AGENDA MEMORANDUM

Planning Commission Meeting of September 15, 2021

Country Acres Subdivision, Lots 4A & 4B (Replat)

Request for a Waiver of the Wastewater Infrastructure Construction Requirement in Sections 8.1.4.C, 8.1.5, and 8.2.7.A of the Unified Development Code (UDC) and exemption from lot/acreage fees

Exhibit D

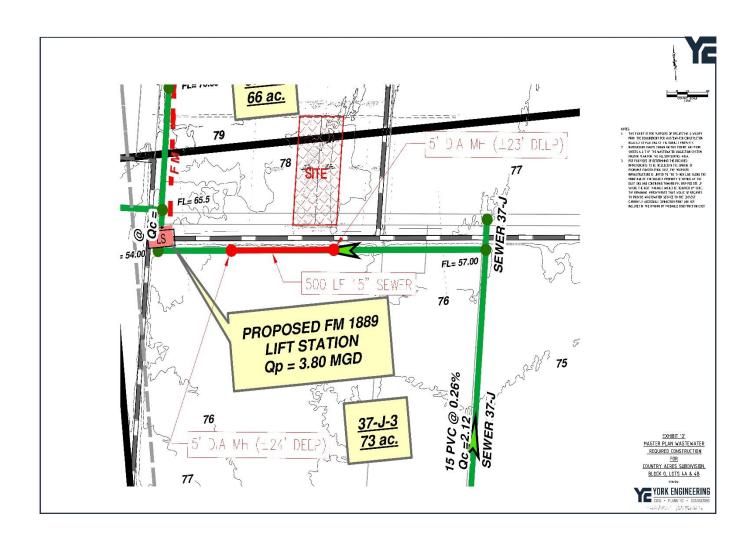
York Engineering provided information on how the property could be served by sanitary sewer. The property could connect to the nearest accessibility point by installing a 15" PVC line along the frontage of Lots 4A & 4B with a manhole on the east frontage. The 15" line would connect west to a manhole at a depth proposed by the Wastewater Master Plan (Exhibit D) at the intersection of CR 48 and FM 1889. The Master plan shows the manhole at this intersection connecting into a proposed Lift Station. A force main connects north along FM 1889 to a manhole at the intersection with County Road 52 Flow would continue east along CR 52 to a series of collection lines and manholes. The connection ends at the accessibility point, which is the Lift Station listed at 2.84 miles from the property on CR 52.
